STAFF RECOMMENDATION
2809 27th Avenue South
July 15, 2020

Application: New Construction—Addition to an Outbuilding; Setback Determination

Description of Project: Application is to construct an addition to an existing outbuilding and to reduce the right-side setback from five feet (5') to three feet, two inches (3' 2").

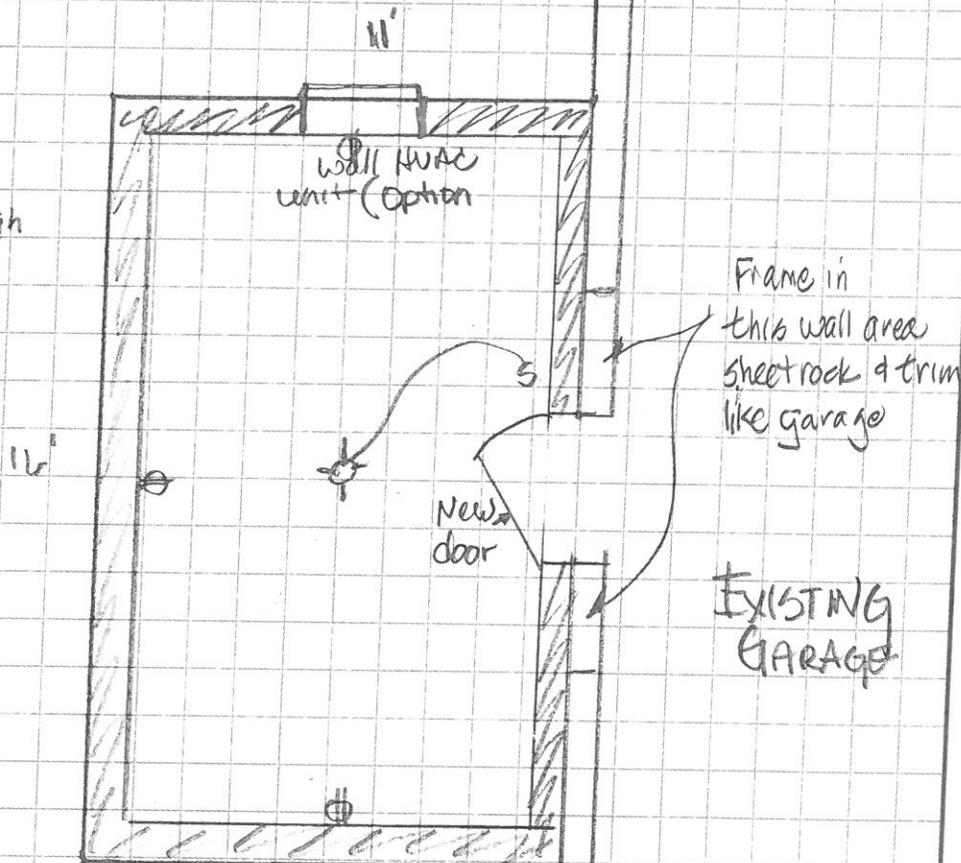
The existing outbuilding has a cross-gable roof form with a 9/12 pitch. Staff finds the shed roof form of the addition to be appropriate given its single-story scale.

Design Standards: The existing outbuilding is two stories, and the proposed addition will be one-story. The addition has a simple design that can be appropriate for a single-story addition. Staff finds that the proposed design meets Section II.B.h.1 of the design guidelines.

The materials for the addition will match those previously approved for the outbuilding. The addition will not include any new exterior windows or doors. Staff finds that the materials meet Section II.B.h.1 of the design guidelines.
